# Dynamic Channel Change Proposal For DOCSIS 1.1

Document: docsis-dcc-<date>.<filetype>

Rev 0.99 May 30, 2000

RFI-N-00021

Figure 6-30. Dynamic Channel Change Response

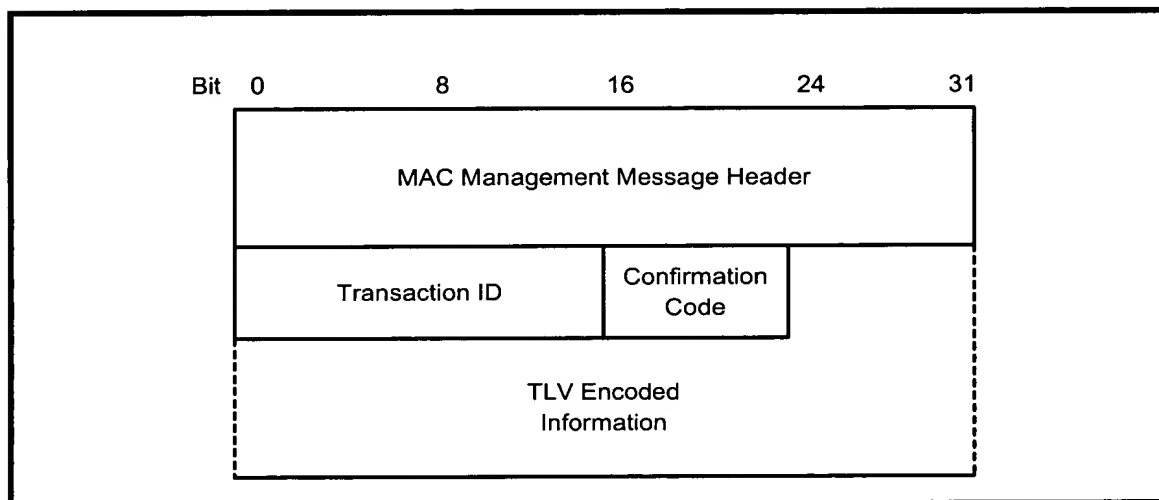
- Added Grant-Sync TLV per ECN-RFI-00009.
  - Fixed type in Interleaver dept. J parameter was missing.
- **6.3.21 DCC-RSP**
  - Added HMAC digest
  - Changed figure to allow TLV field.

Figure 9-21. Dynamically Changing Channels: CM View Part 2

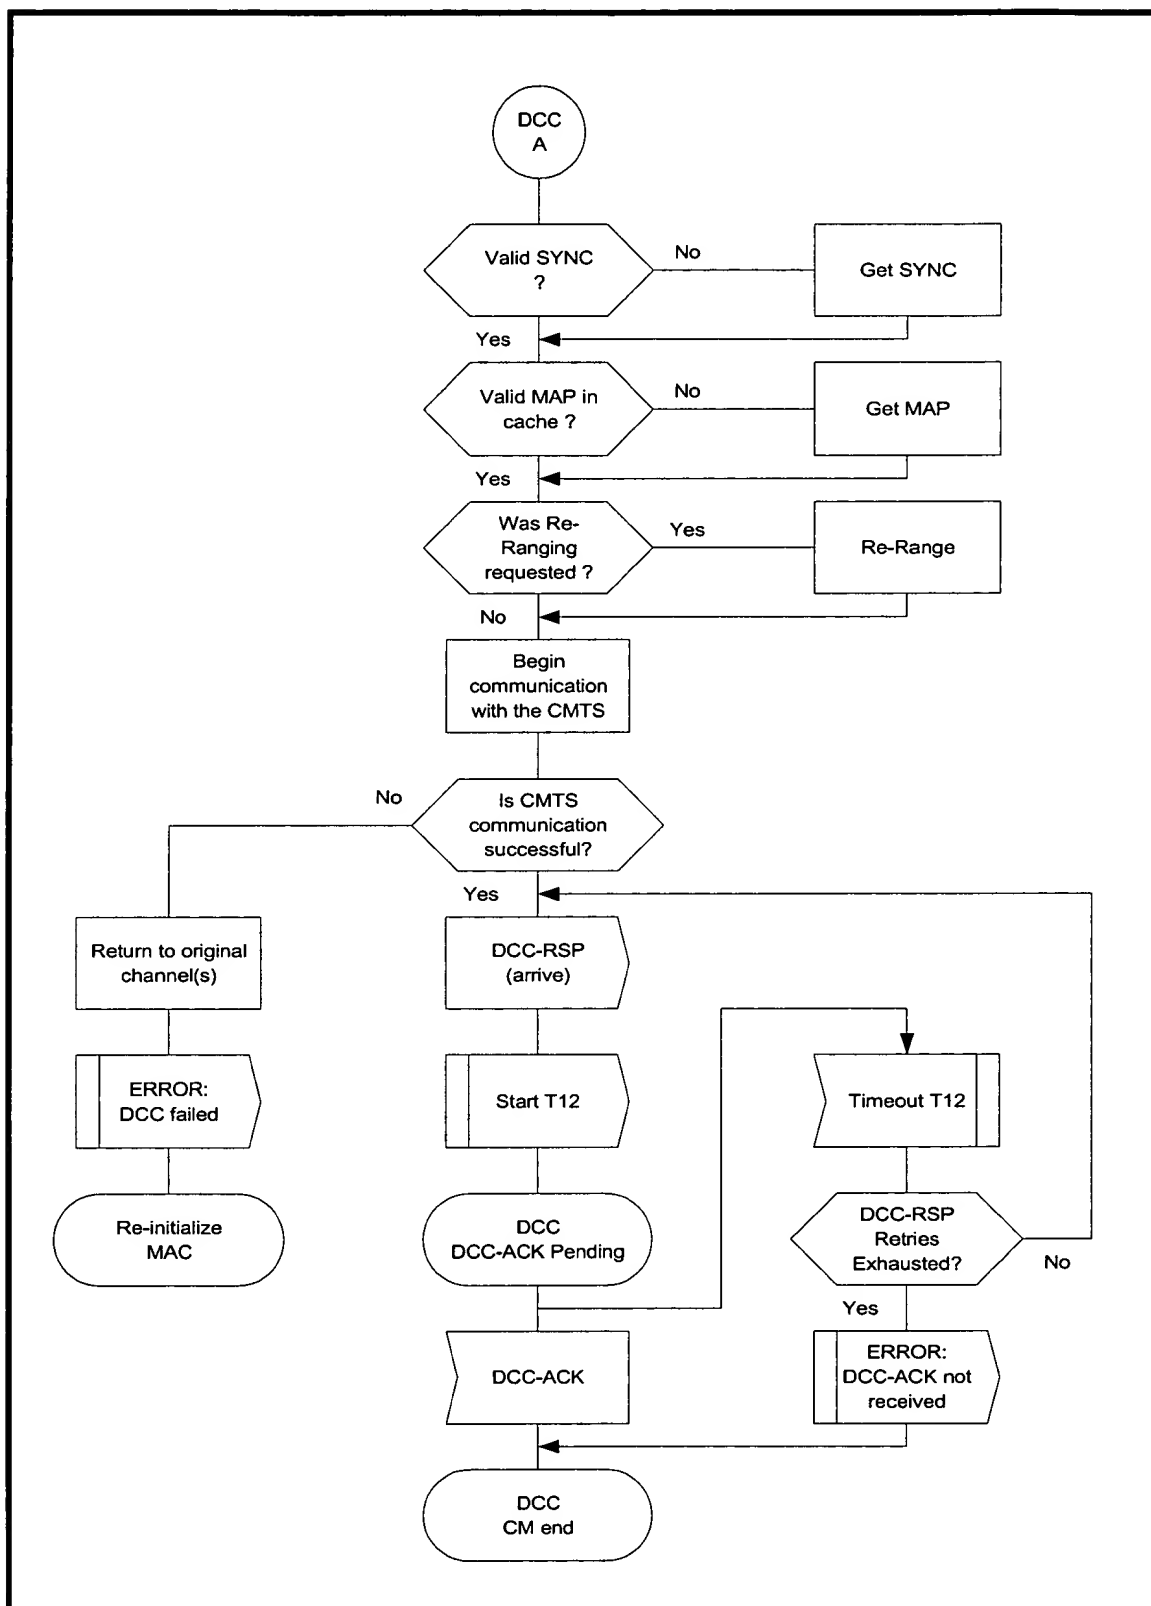
- **6.3.20 DCC-REQ**
  - Added SFID Substitution ID TLV back in.
  - Added Classifier ID Substitution TLV
  - Added PHSI Substitution TLV
- **Figures**
  - Figure 9-21, CM SM part 2 was down-rev. Update inserted.

Figure H-1. Single Downstream and Single Upstream Channels per CM

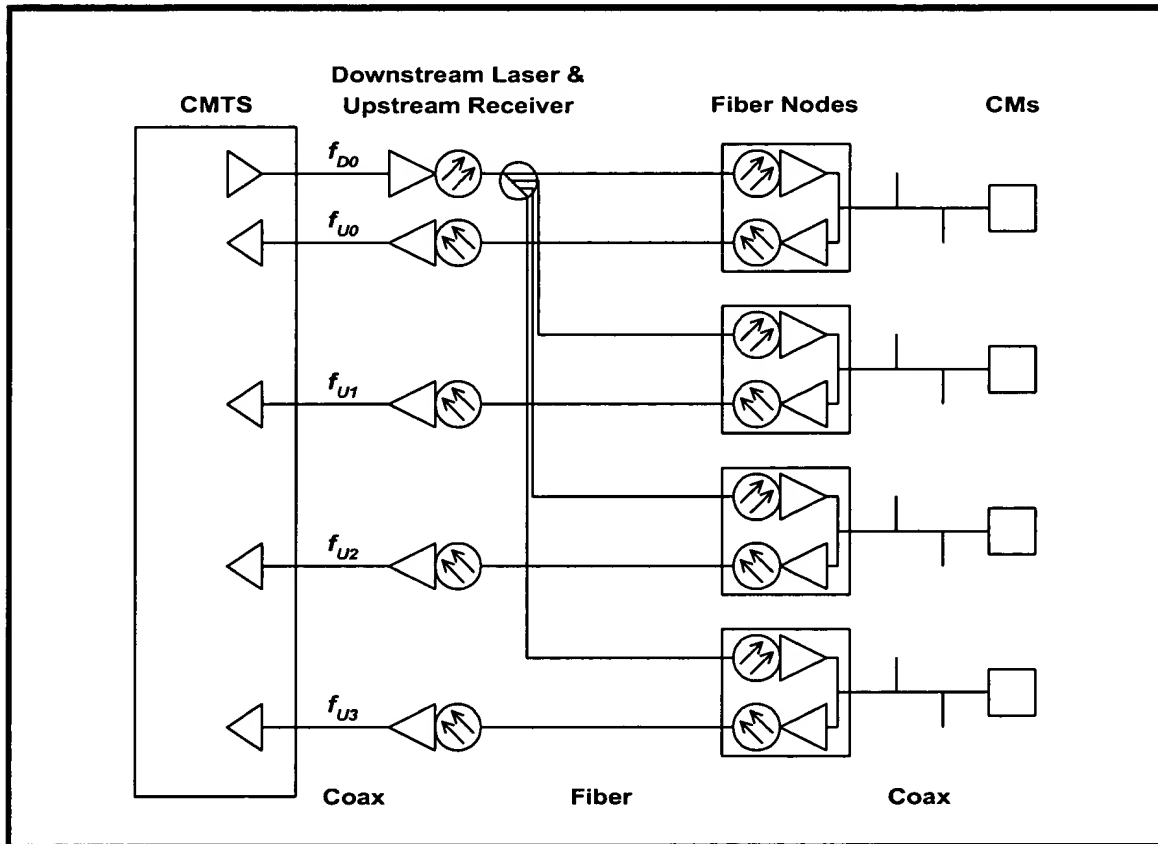
- Appendix H.1: Redrew the diagram. Clarified and updated text. Changed MUST to SHOULD on all upstreams being the same frequency. This is to allow for spectrum management techniques.
